Addendum 2

Project: **BRFP NUMBER 2324-03 – TROY SCHOOL DISTRICT 2024 SITE IMPROVEMENTS PAVING PROJECTS**

PROJECT: 2024 Troy School District Site Improvements – Paving Projects
DATE: November 14, 2023
FROM: PEA Group
PEA JOB No.: 23-0262
PURPOSE: Addendum Number 2

C-1.1

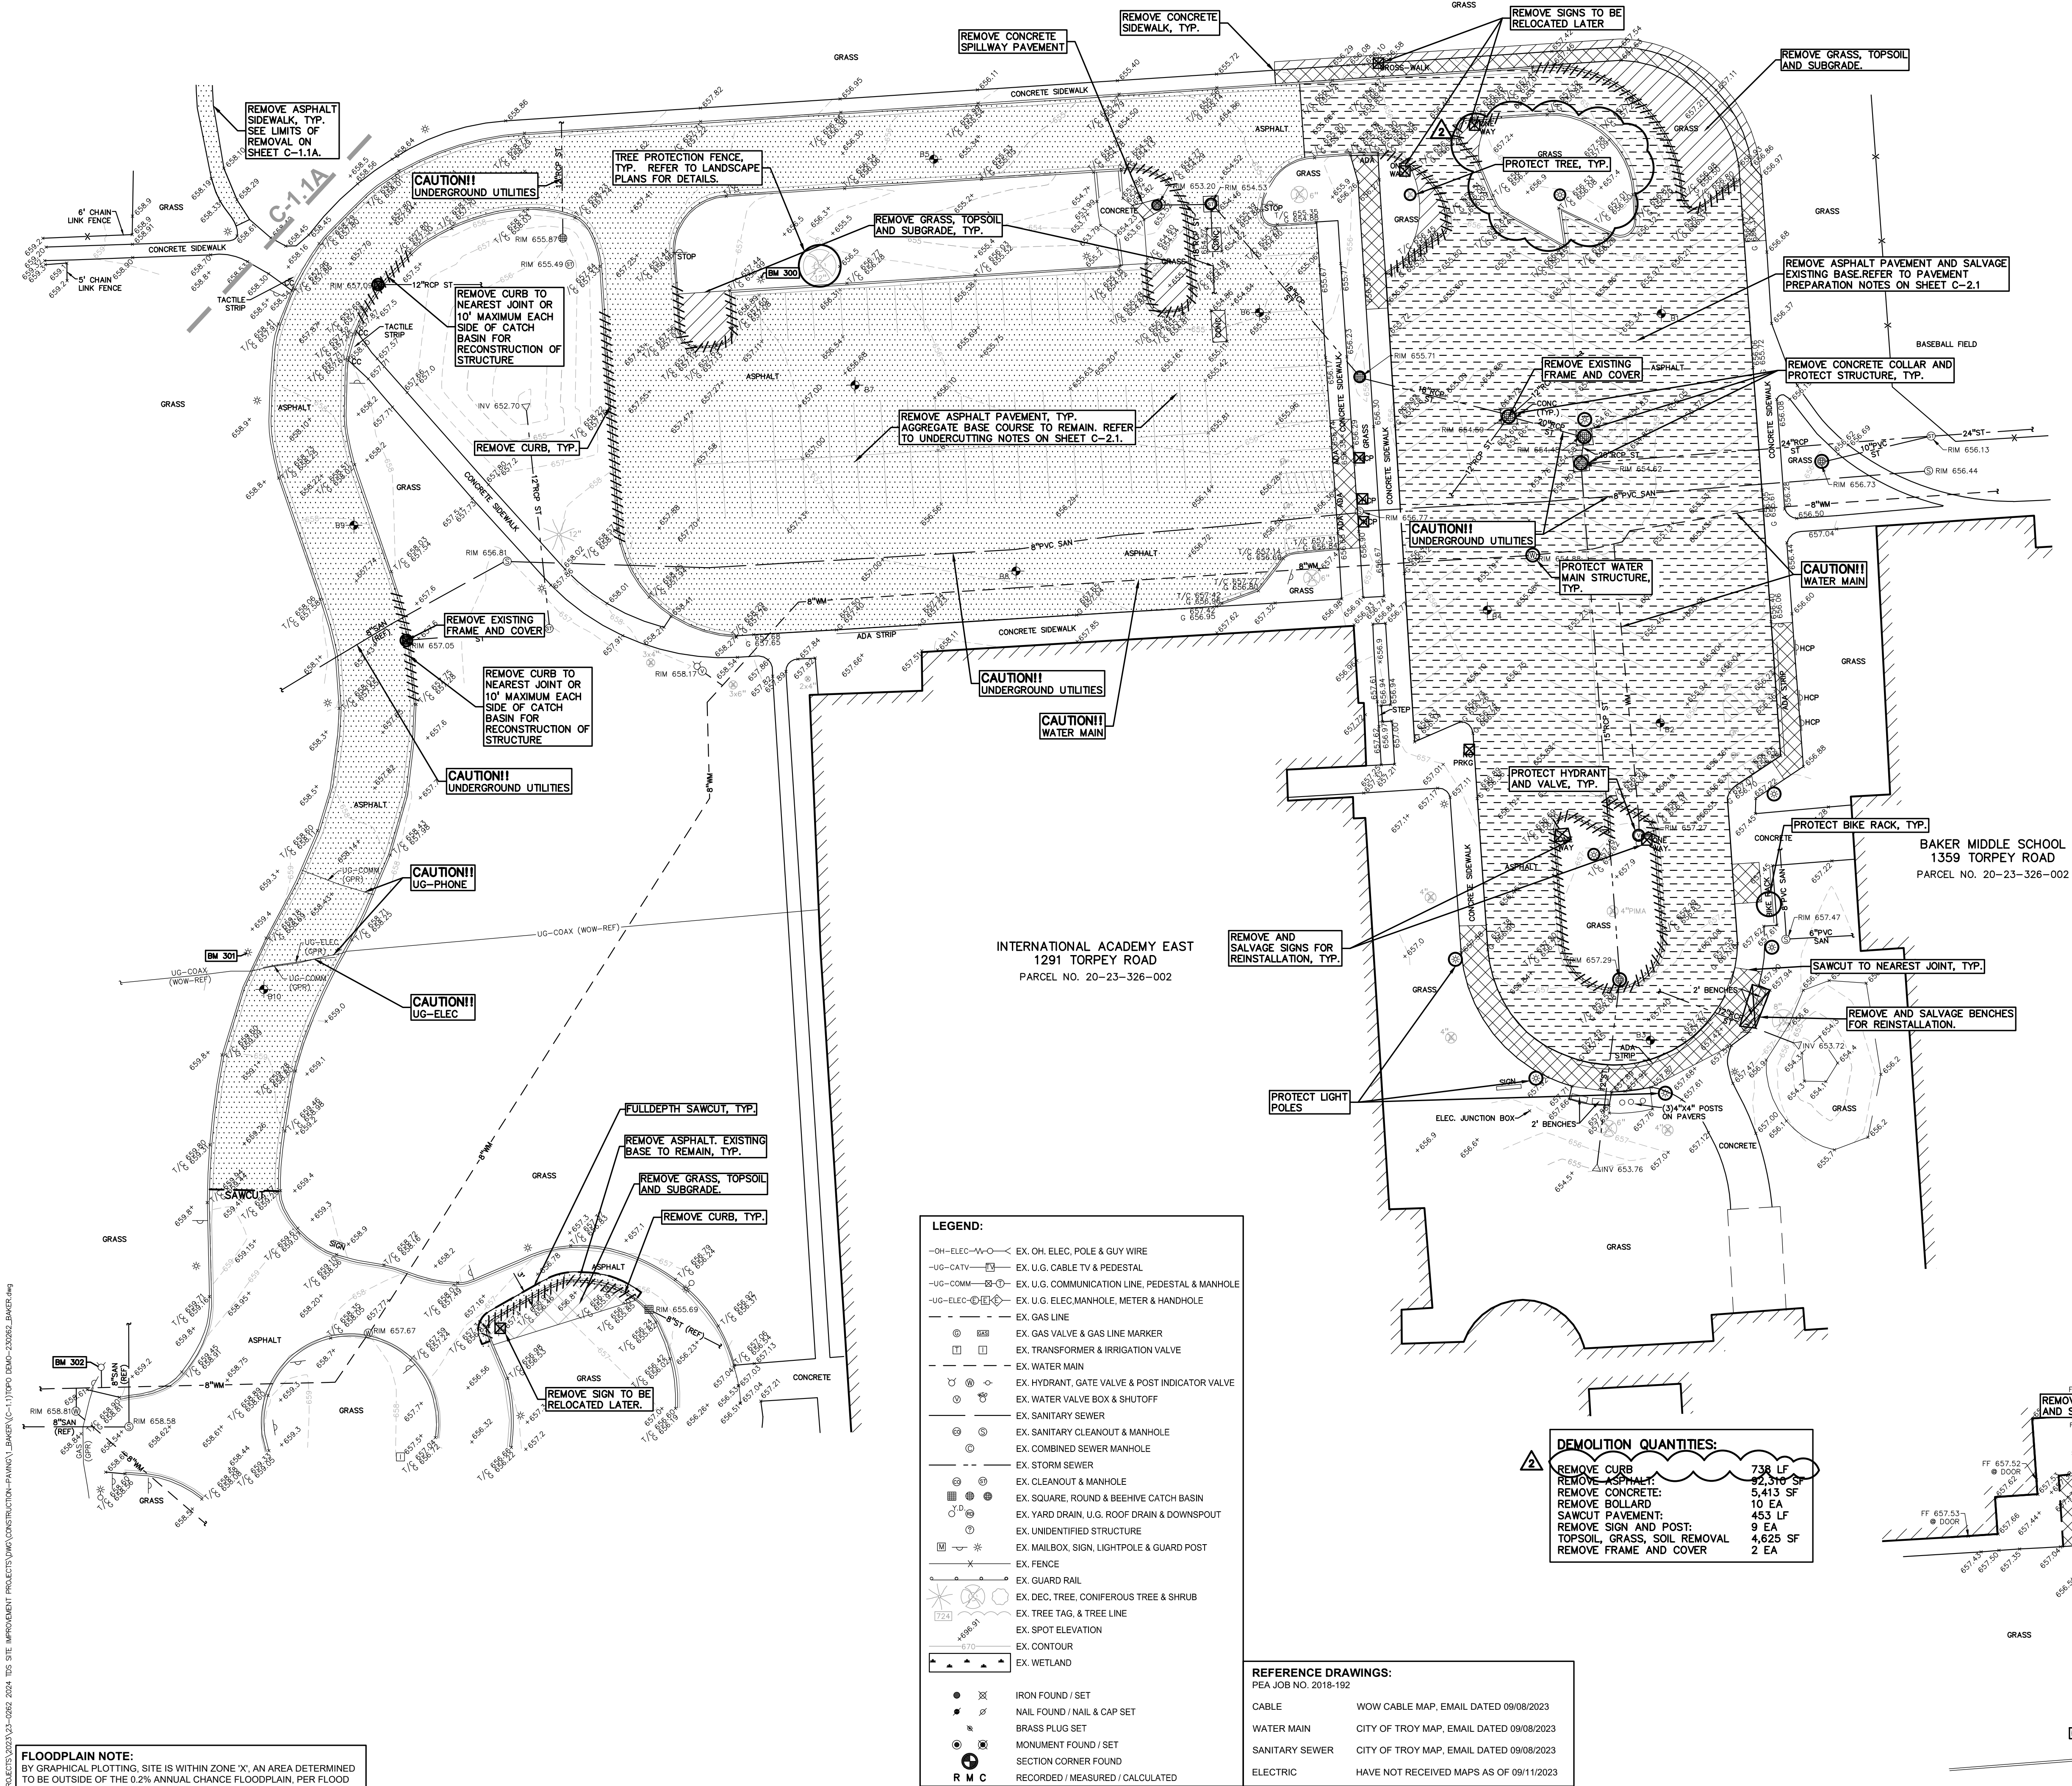
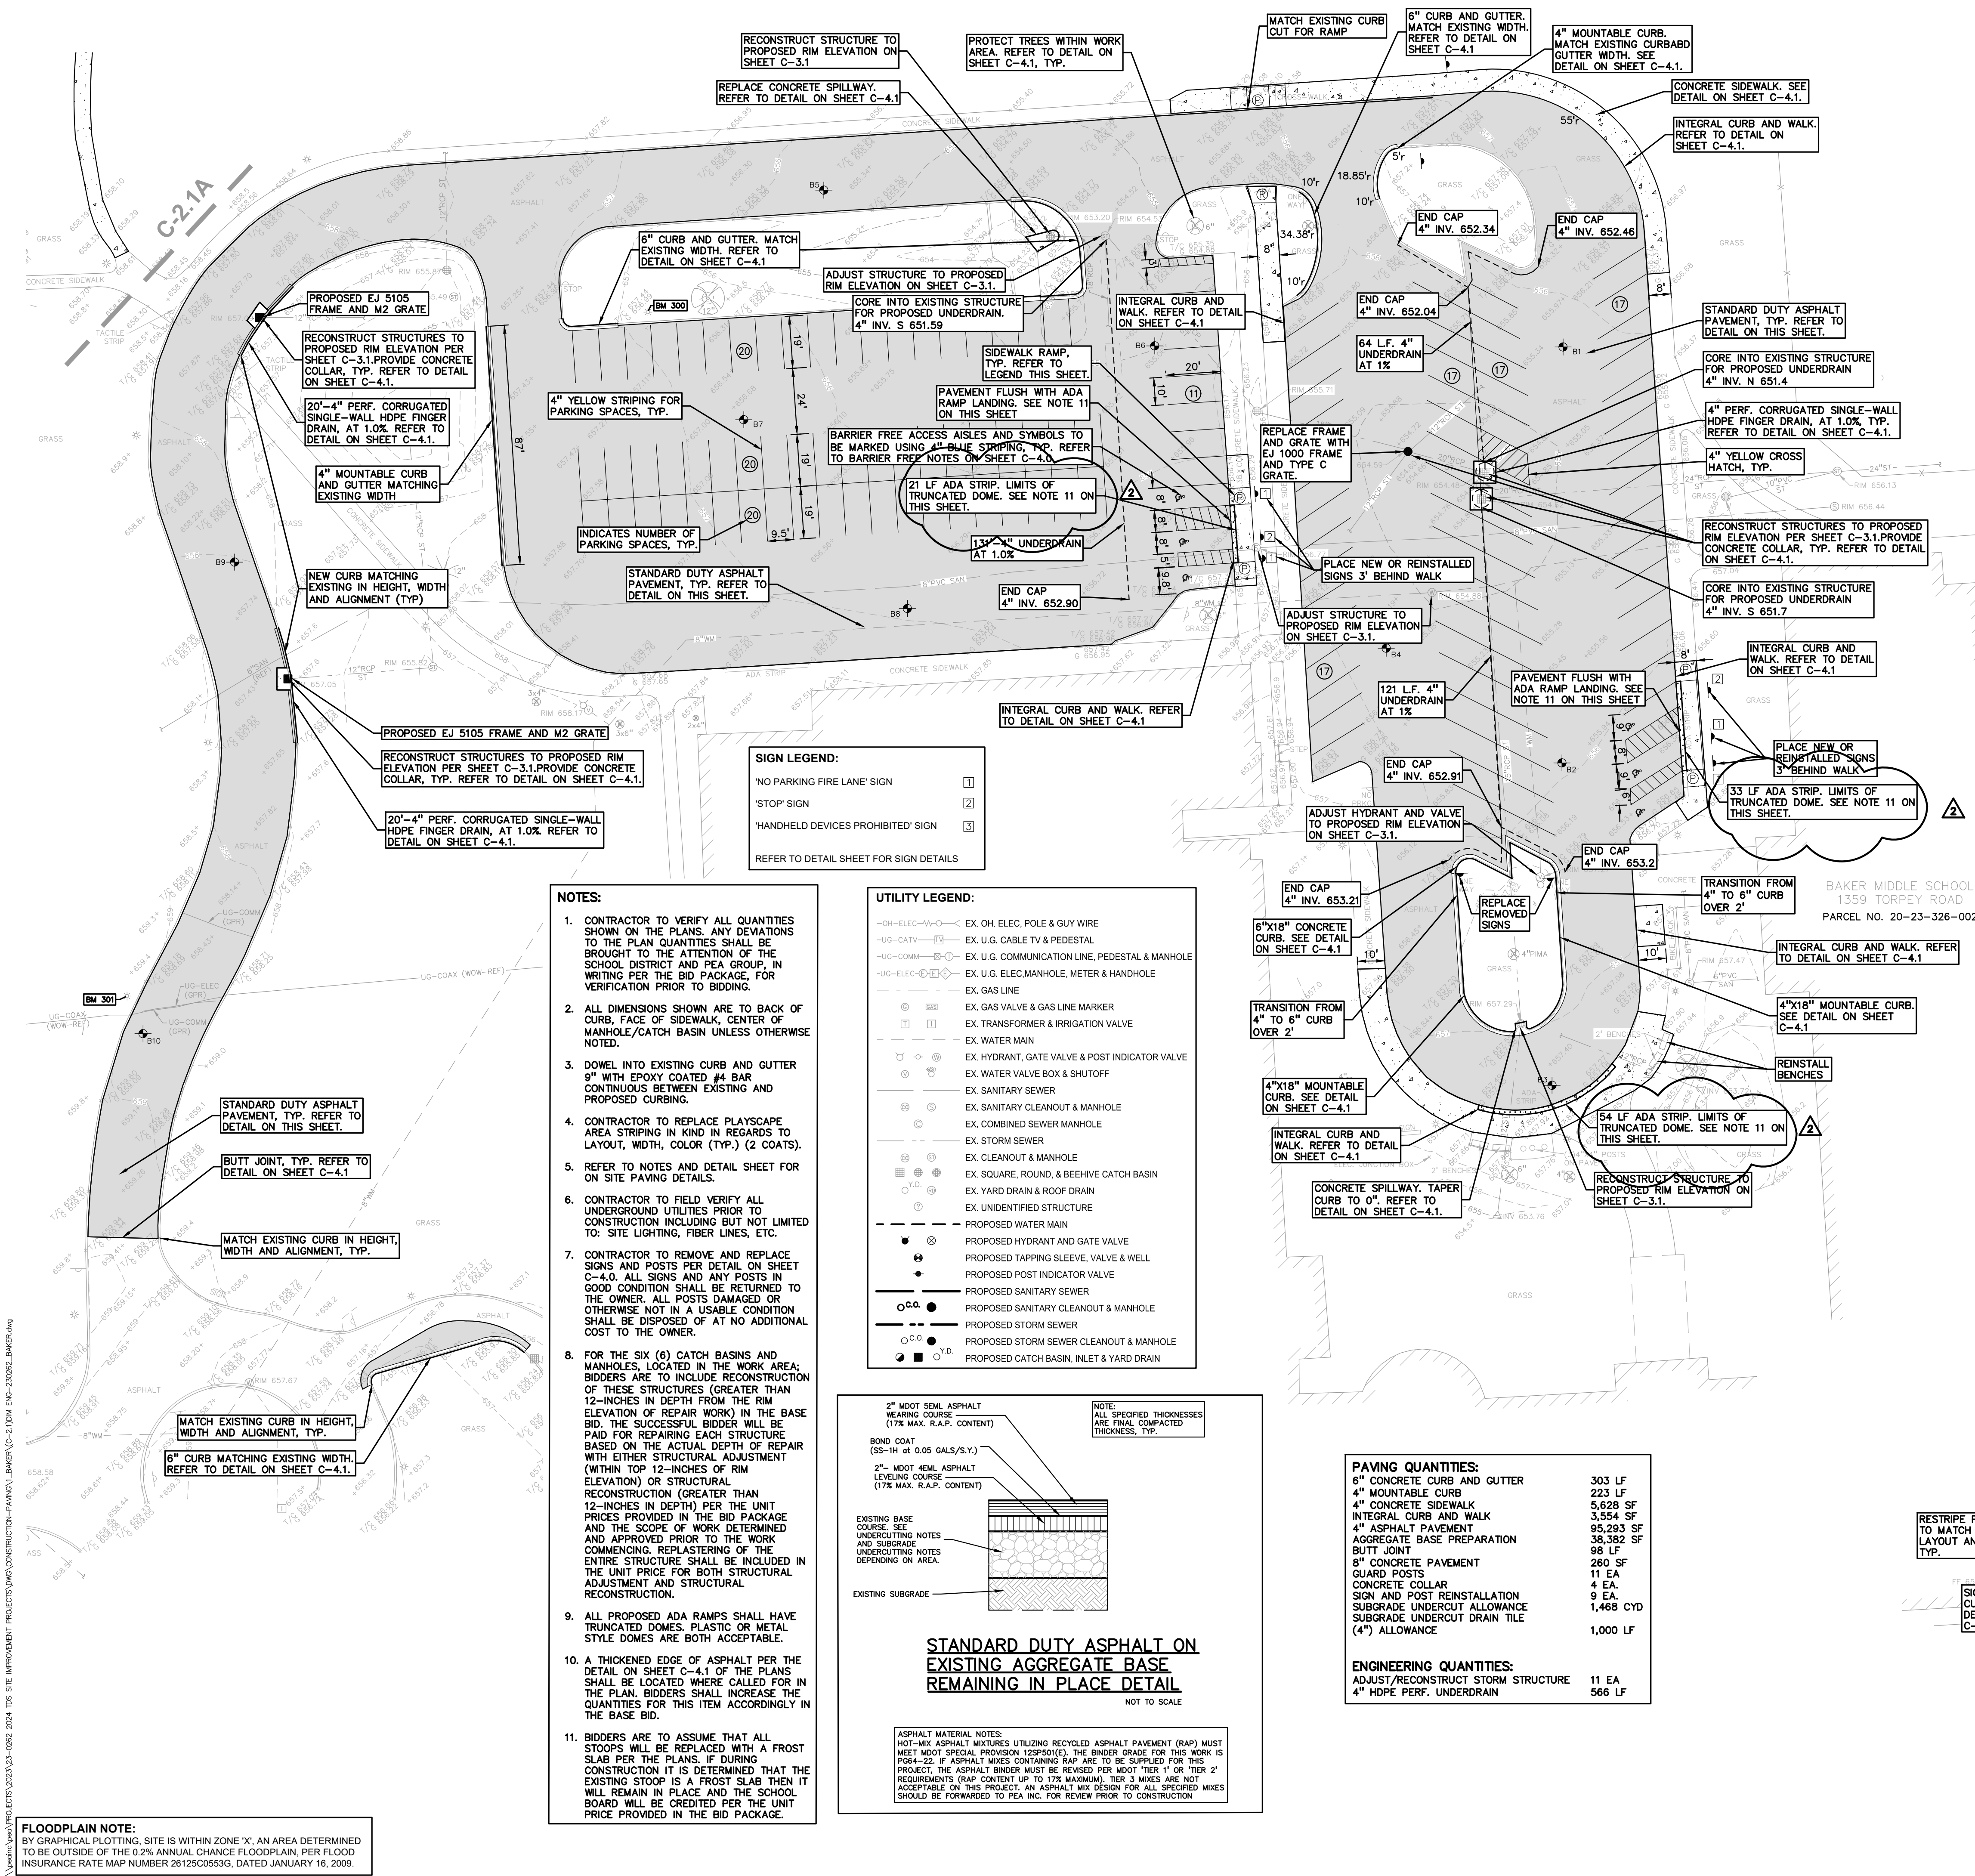
1. Limits of curb removal of the island in the northeast corner of the site have been updated to match sheet C-2.1.

PEA JOB NO. 2023-0262
P.M. RR
DN. RR
DES. RM
DRAWING NUMBER:
C-2.1

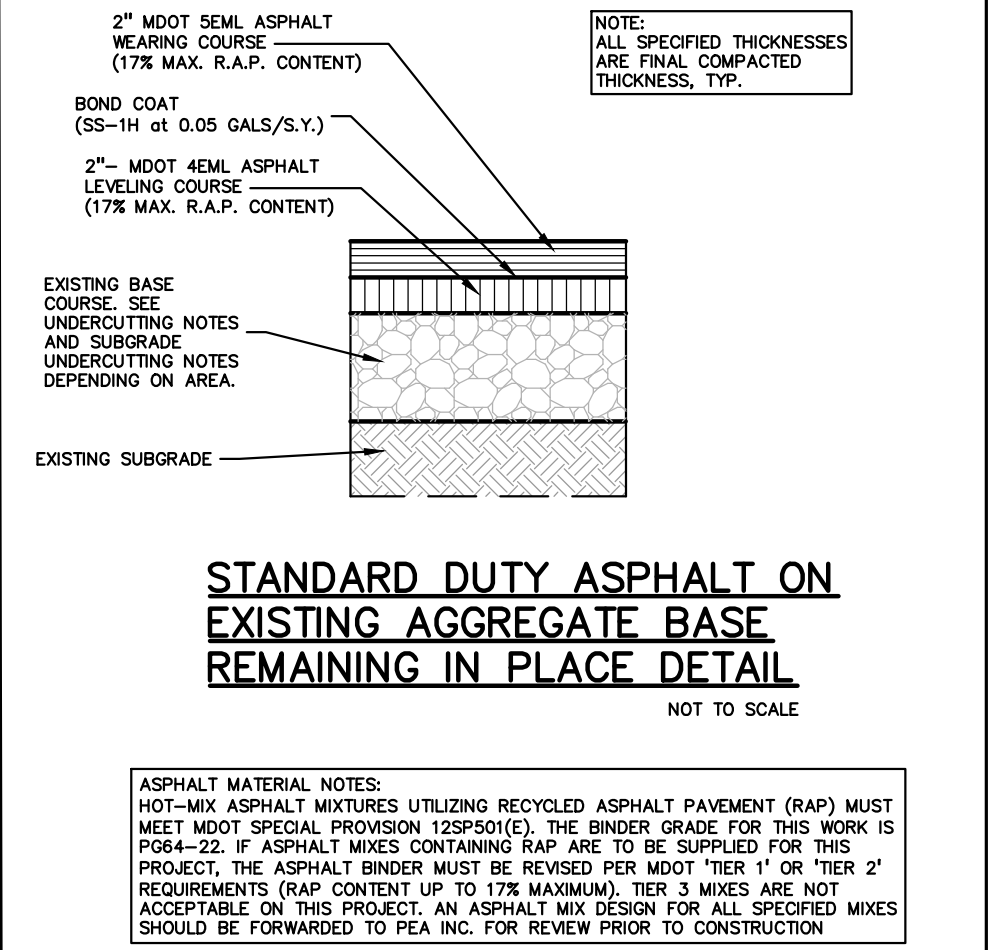
Limits of the proposed truncated domes at the ADA curb ramps were defined with a new hatch and linear footage was provided.
